Access Compliance Report Public Rights-of-Way (Curb Ramps)

Main Street: FOSTER_RD Cross Street: DRUID_LN Location: N

ADA ID: RPRK211207112824 Ramp Type: Type 4 - Parallel Initial Pass/Fail: Fail Overall Compliance: No Severity Score: 2

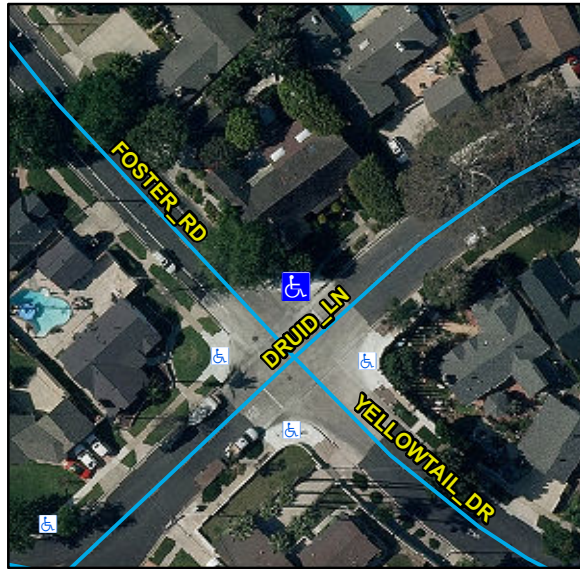
Surveyor Notes:

N/A

Compliance	Description	Data	Compliance	Description	Data
N/A	Ramp Length LT (in)	89	N/A	Ramp Length RT (in)	88
Yes	Ramp Width LT (in)	71	Yes	Ramp Width RT (in)	81
Yes	Ramp Run Slope LT (%)	5.6	Yes	Ramp Run Slope RT (%)	6.2
No	Ramp Cross Slope LT (%)	3.3	No	Ramp Cross Slope RT (%)	5
N/A	Landing Present	N/A	N/A	DWS Provided	N/A
N/A	Landing Length (in)	N/A	N/A	DWS Contrast	N/A
N/A	Landing Width (in)	N/A	N/A	DWS Length (in)	N/A
N/A	Landing Run Slope (%)	N/A	N/A	DWS Full Width	N/A
N/A	Landing Cross Slope (%)	N/A		DWS Offset Type	N/A
N/A	Landing Movement Obstructed?	N/A	N/A	DWS Offset Left (in)	N/A
	Landing Movement Type	N/A	N/A	DWS Offset Right (in)	N/A
N/A	Landing Shared	N/A			
N/A	Clear Space	Yes			
N/A	Clear Space To Crosswalk (in)	N/A			
N/A	Marked Crosswalk 1	No	N/A	Marked Crosswalk 2	No
	Crossing 1 Direction	SW		Crossing 2 Direction	SE
	Marked Crosswalk 1 Width (in)	N/A		Marked Crosswalk 2 Width (in)	N/A
N/A	Ramp Inside Crosswalk 1	N/A	N/A	Ramp Inside Crosswalk 2	N/A

Remove & Replace Curb Ramp With Two New Directional Ramps or Equivalent.

R304.5.3, STD 1115
